Docket Item #6
Development Special Use Permit #2025-10015
Special Use Permit #2025-00048
2051 Jamieson Avenue – Carlyle Block B Conversion

Application	General Data	
Project Name: Carlyle Block B - Office to Residential Conversion	PC Hearing:	November 6, 2025
	CC Hearing:	November 15, 2025
	If approved, DSUP Expiration:	November 15, 2028
	Plan Acreage:	0.9 acres (39,017 sf)
Location: 2051 Jamieson Avenue	Zone:	CDD#1 / Coordinated Development District #1
	Proposed Use:	Multi-unit Residential
	Dwelling Units:	181 (retail option) 187 (all residential option)
	Gross Floor Area:	214,228
	Net Floor Area:	189,422
Applicant: Red Fox Development, represented by W. Kenneth Wire, attorneys	Small Area Plan:	Eisenhower East Small Area Plan
	Historic District:	N/A
	Green Building:	Complying with 2019 Green Building Policy
Purpose of Application: The applicant requests approval of a Development Special Use Permit amendment and a Carlyle Special Use Permit amendment, to construct an addition and convert an existing office building into an 187-unit multi-unit residential building, and with associated site improvements.

DSUP #2025-10015 / SUP #2025-00048
2051 Jamieson Avenue – Carlyle Block B Conve

Block B, Page 8 of 8

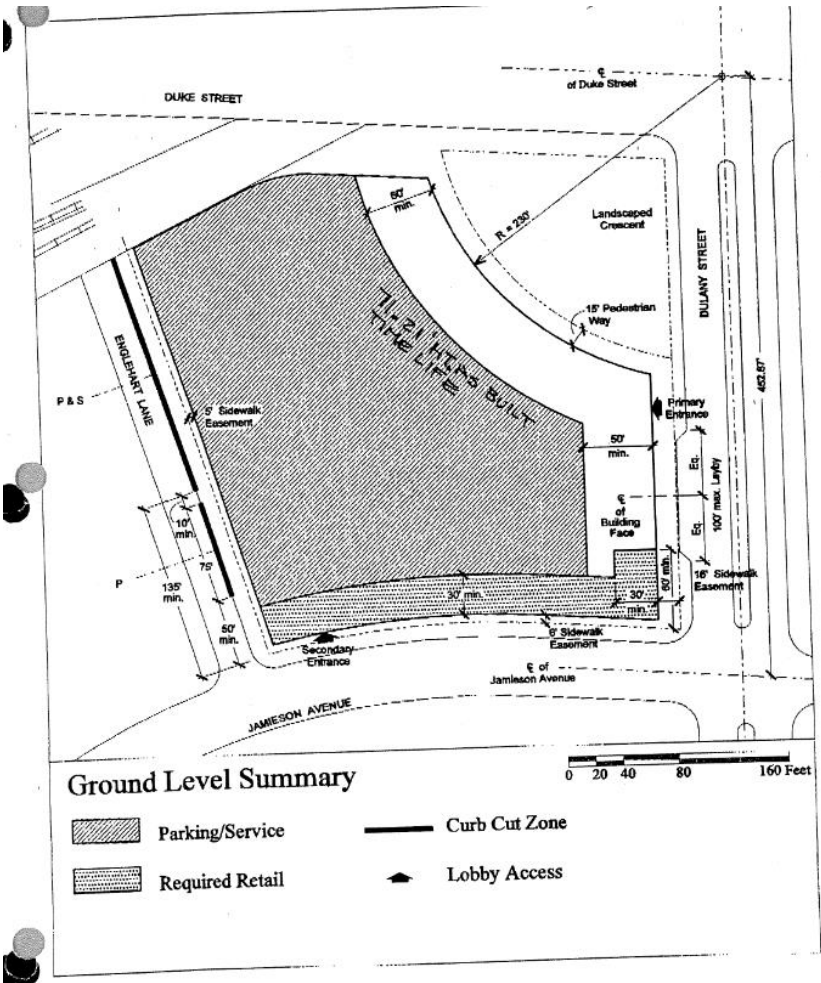
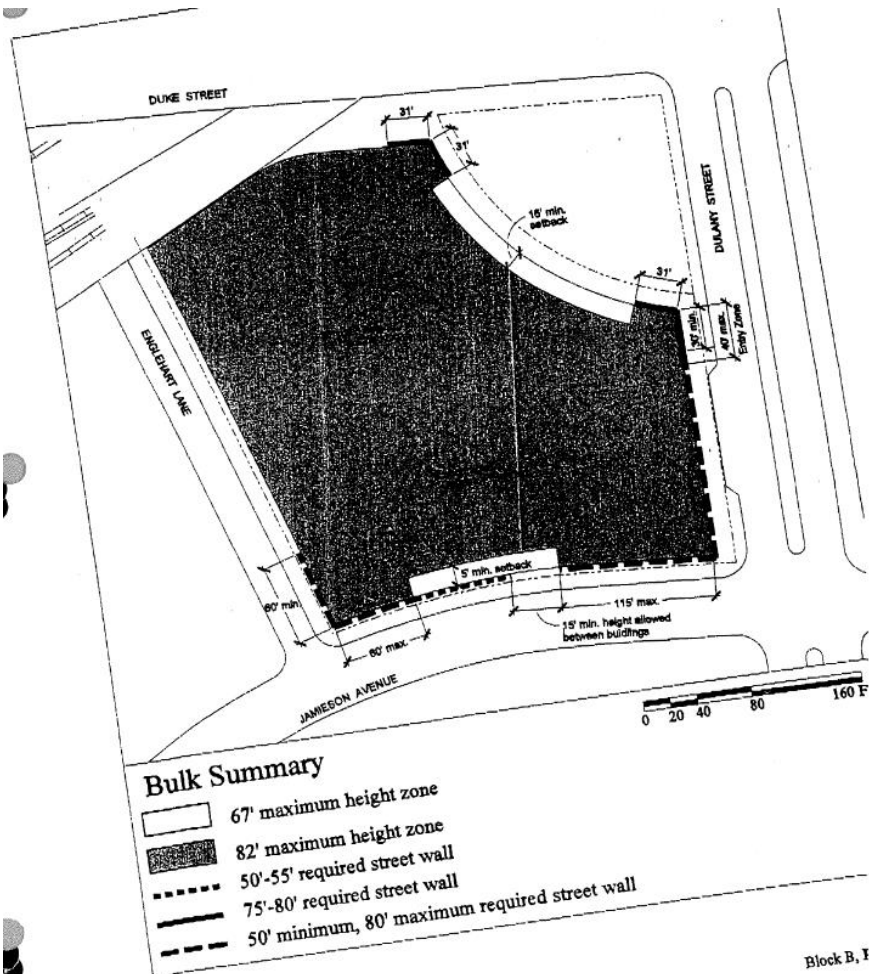
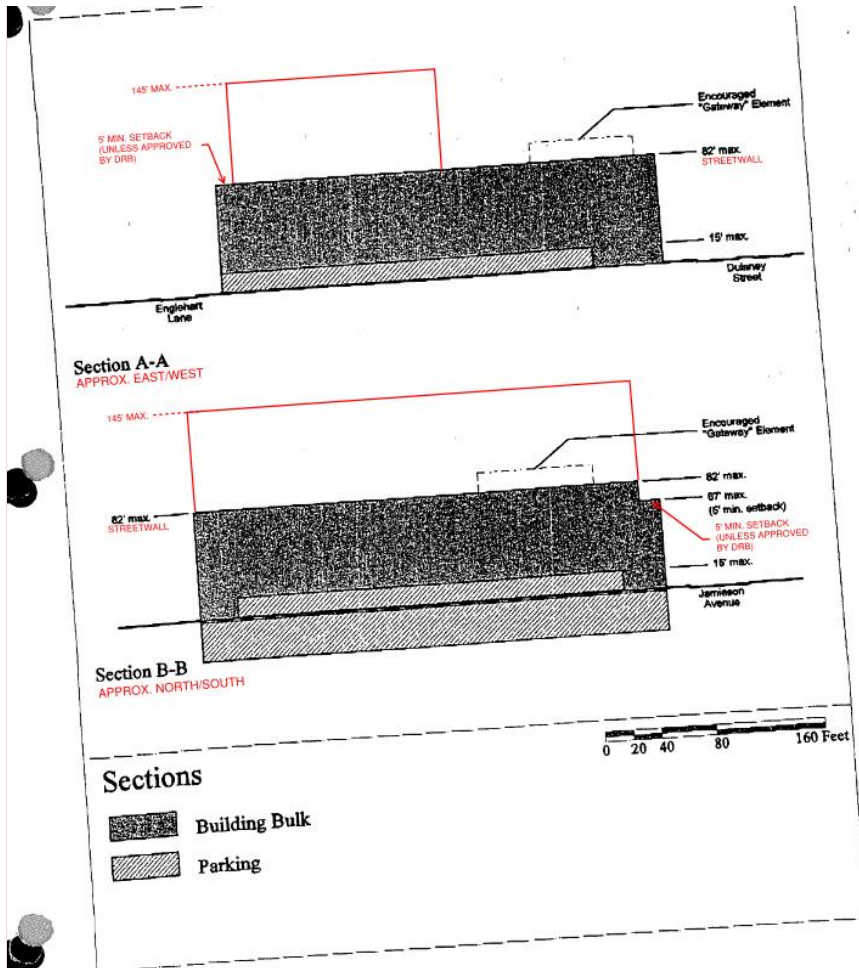
Commented [AP1]: TO APPLICANT TEAM: Change max height in the max height in the illustration on this page to 146 feet instead of 145 feet.
